UNITED STATES PATENT AND TRADEMARK OFFICE

APPLICATION NO.	FILING DATE	FIRST NAMED INVENTOR	ATTORNEY DOCKET NO.	CONFIRMATION NO.
09/970,104	10/03/2001	Motohiro Suzuki	SIW-013	1403
959	7590	06/02/2004	EXAMINER	
LAHIVE & COCKFIELD, LLP. 28 STATE STREET BOSTON, MA 02109			ALEJANDRO, RAYMOND	
			ART UNIT	PAPER NUMBER
			1745

Office Action Summary

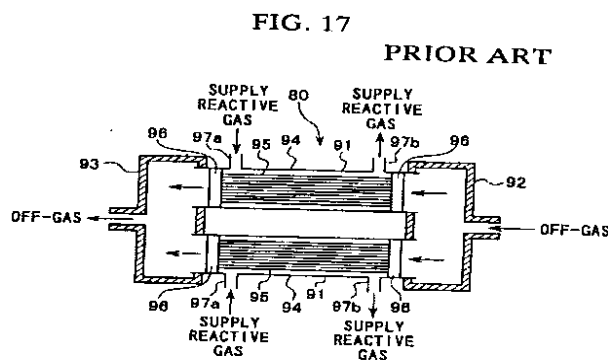
As shown in Figure 17 above, the humidifier has a liquid exhaust mechanism including two supply reactive gas outlets: an upper supply reactive gas outlet 97b and a lower supply reactive gas outlet 97a as indicated by stream flow arrow in Figure 17. Thus, it is noted that the lower supply reactive gas outlet 97a from which humidified supply reactive gas is exhausted is positioned below both the off-gas flow entrance as well as below, at least, an upper supply

reactive gas inlet 97a. Thus, the humidifier of Figure 17 satisfies the required functional and structural relationship of the claimed invention.

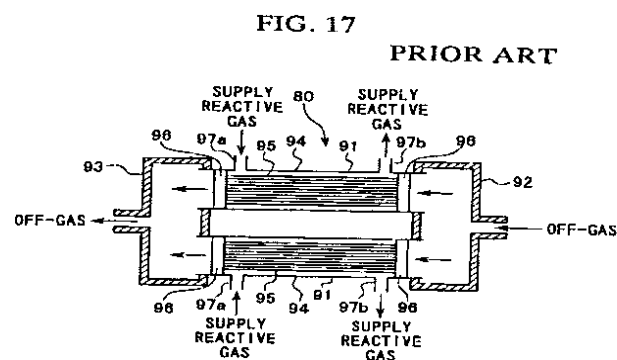
As shown in Figure 17 above, the humidifier has a liquid exhaust mechanism including two supply reactive gas outlets: an upper supply reactive gas outlet 97b and a lower supply reactive gas outlet 97b as indicated by stream flow arrow in Figure 17. Thus, it is noted that the lower supply reactive gas outlet 97b from which humidified supply reactive gas is exhausted is positioned below both the off-gas flow entrance as well as below, at least, an upper supply

reactive gas inlet 97a. Thus, the humidifier of Figure 17 satisfies the required functional and structural relationship of the claimed invention.

FIG. 17

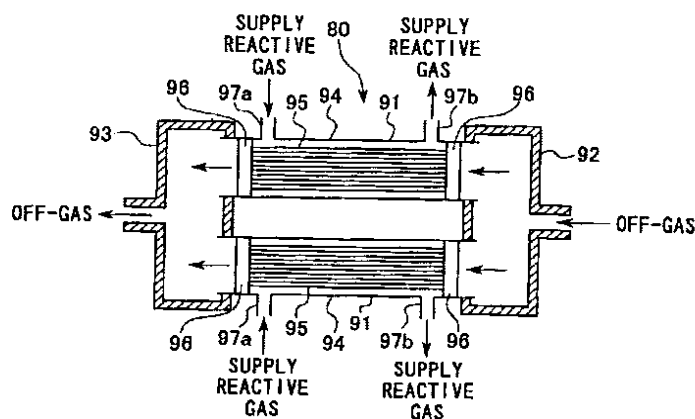
As shown in Figure 17 above, the humidifier has a liquid exhaust mechanism including two supply reactive gas outlets; an upper supply reactive gas outlet 97b and a lower supply reactive gas outlet 97b as indicated by stream flow arrow in Figure 17. Thus, it is noted that the lower supply reactive gas outlet 97b from which humidified supply reactive gas is exhausted is positioned below both the off-gas flow entrance as well as below, at least, an upper supply reactive gas inlet 97a. Thus, the humidifier of Figure 17 satisfies the required functional and structural relationship of the claimed invention.

The main contention of applicants' arguments is now premised on the assertion that the prior art fails to reveal or fairly suggest that "the liquid exhaust mechanism is provided below the off-gas flow entrance or below the supply gas flow exit". However, this assertion is respectfully disagreed with because: i) the examiner has interpreted that "the liquid exhaust mechanism which exhausts liquid" can be the same "reactive gas exit" itself or "the off-gas exit" as such, because they are able to exhaust liquid which has been generated therethrough. In that, the "reactive gas exit" and/ or "the off-gas exit" are inherently recited by the claim because gas entrances and exits are necessarily required in order to supply and remove the gas from the humidifying unit; and ii) as shown in Figure 17 above, the humidifier has a liquid exhaust mechanism including two supply reactive gas outlets: a first upper supply reactive gas outlet 97b

and a second lower supply reactive gas outlet 97b as indicated by stream flow arrow in Figure 17. Thus, it is noted that the lower supply reactive gas outlet 97b from which humidified supply reactive gas is exhausted is positioned below both the off-gas flow entrance as well as below, at least, an upper supply reactive gas inlet 97a. Thus, the humidifier of Figure 17 satisfies the required functional and structural relationship of the claimed invention.
